# CITY OF ALBUQUERQUE

RE: **Bella Vista Assisted Living**  
**13101 Constitution NE**  
**Request Permanent C.O. – Accepted**  
**Engineers Stamp Date 5/14/15 (J22D067)**  
**Certification Dated: 10/13/16**

**BELLA VISTA ASSISTED LIVING**  
ENGINEER'S CERTIFICATION (HYDROLOGY) FOR PERMANENT CERTIFICATE OF  
OCCUPANCY

**RE: Bella Vista Assisted Living, 13101 Constitution Avenue NE  
Grading Plan and Drainage Plan (C-1.0)  
Engineer's Stamp Date 5-14-2015 (File: J22-D067)**

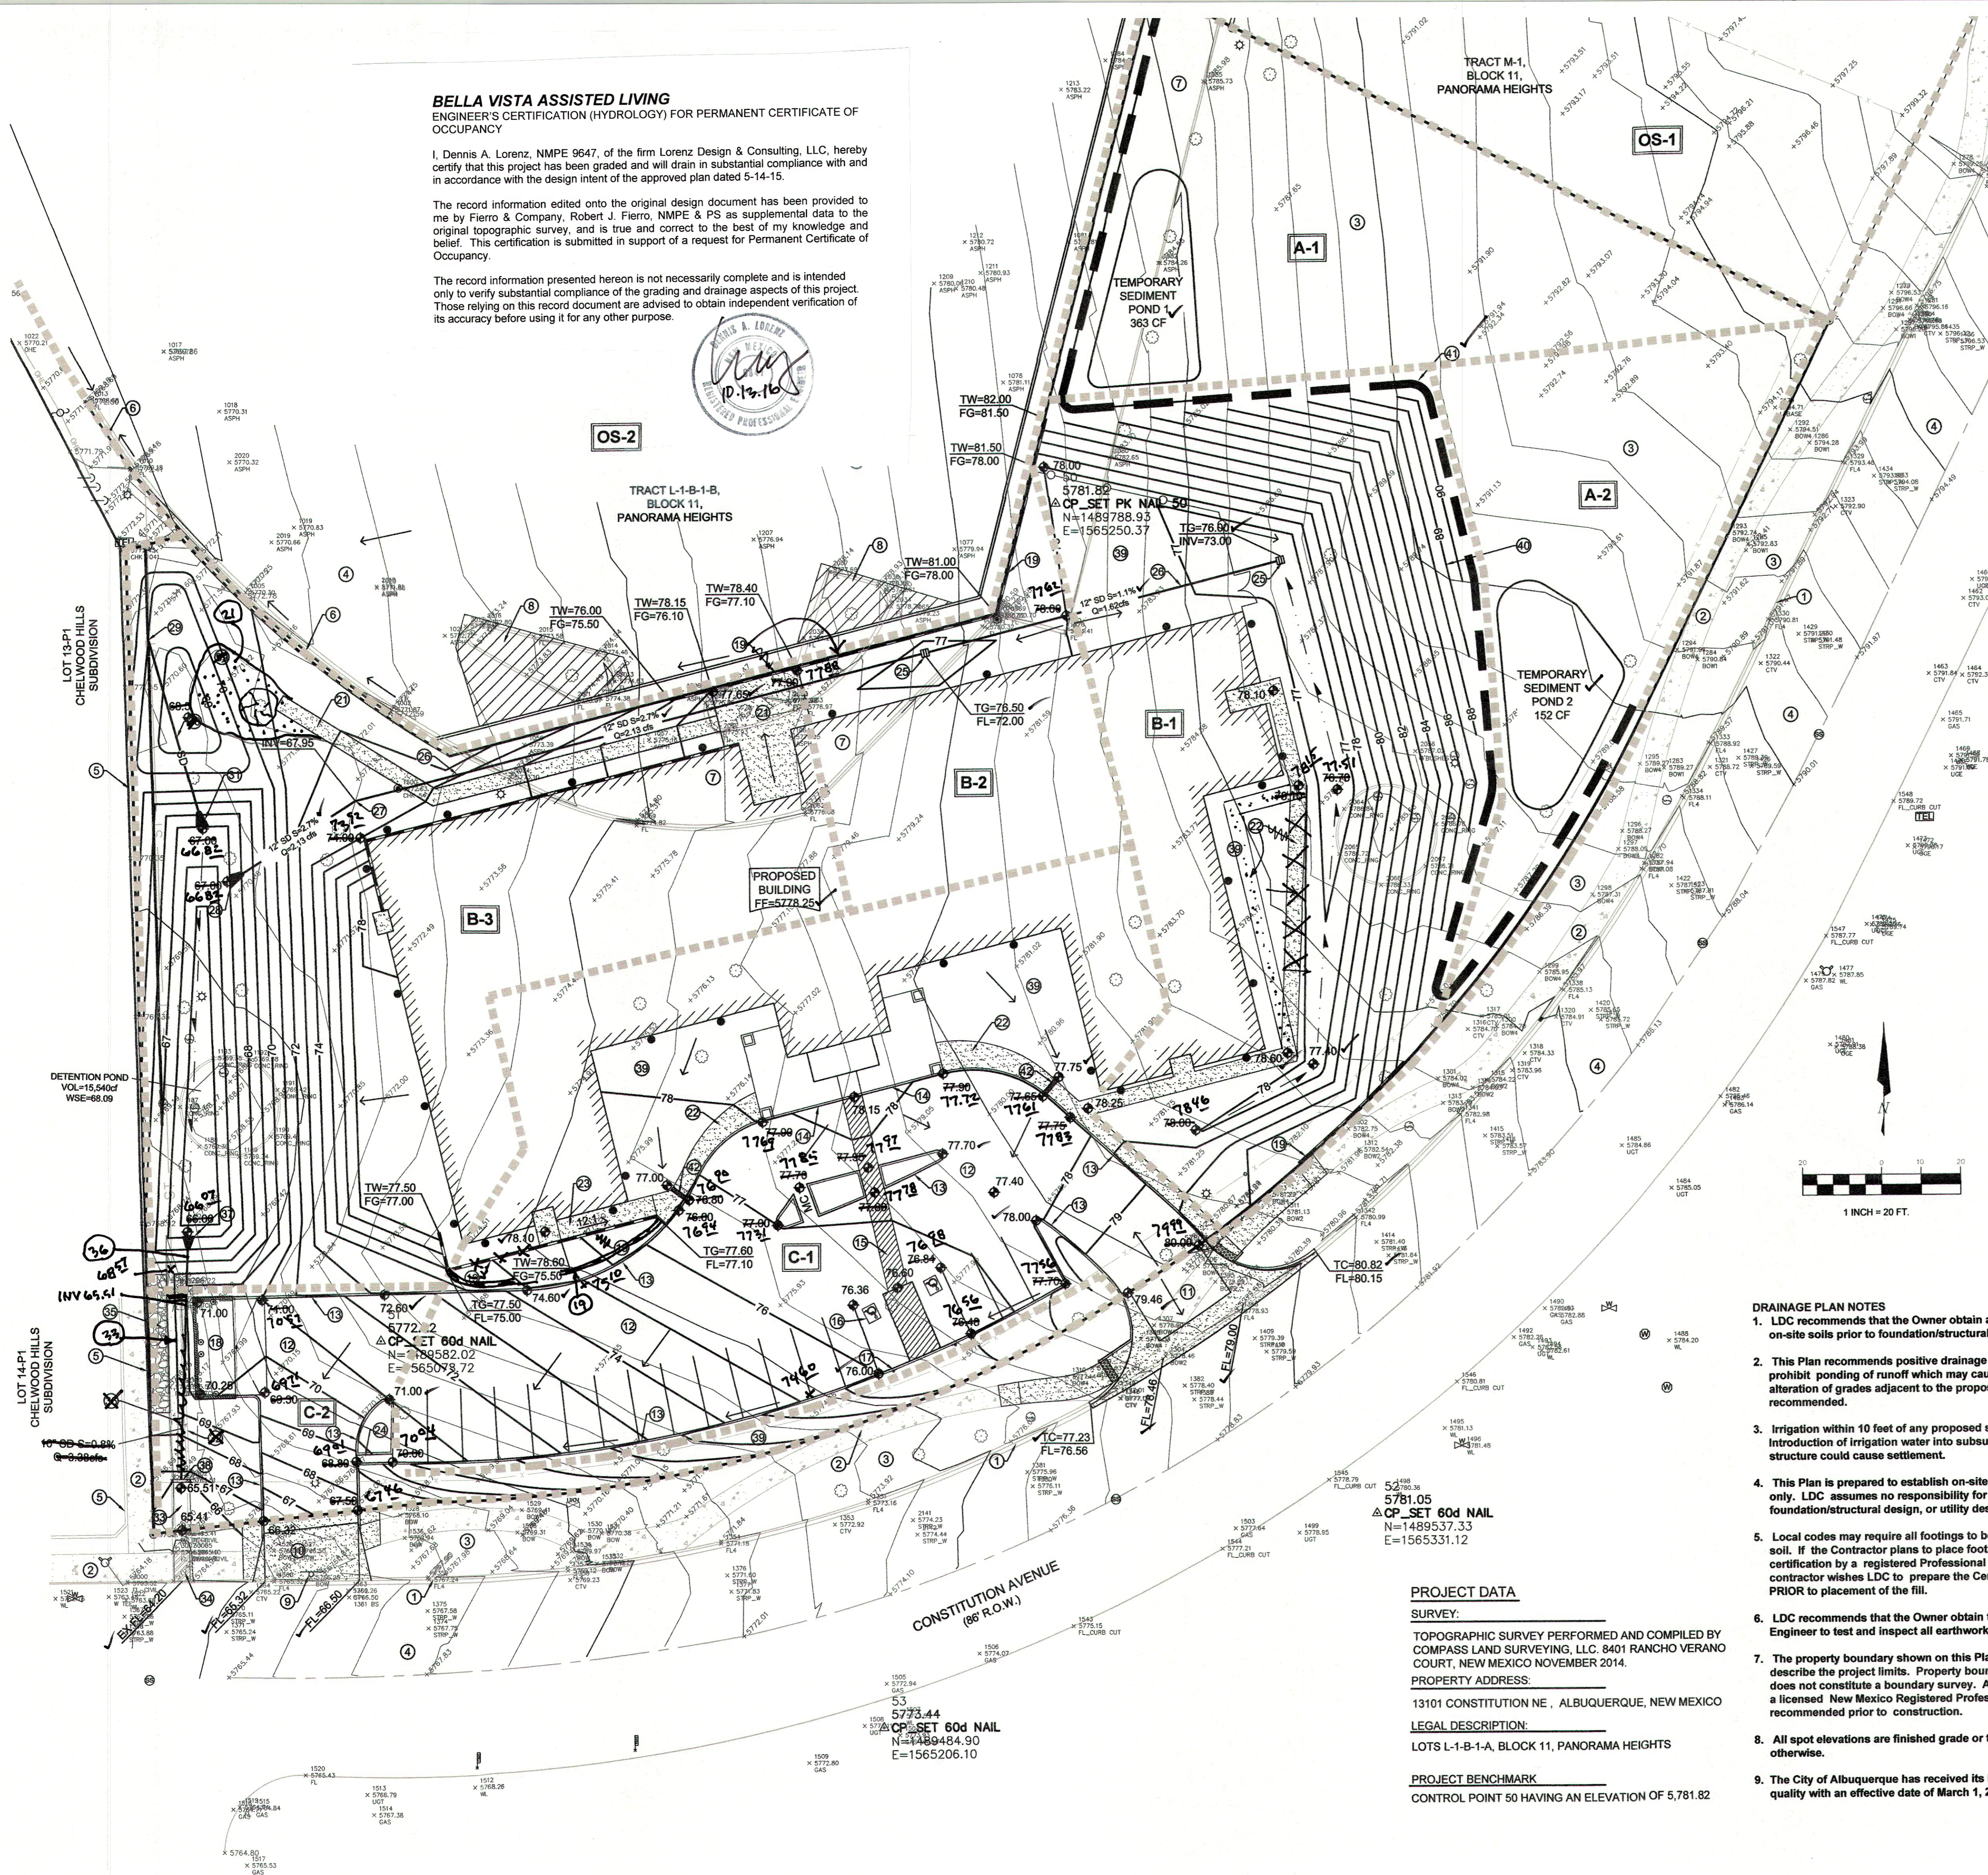
- The owner is to be advised that the splash blocks do not appear to direct the flows on to the sidewalk, but to each side therefore filling the area with water from 5 downspouts between the building and sidewalk. We recommend the owner monitor the drainage on the east side of the facility.
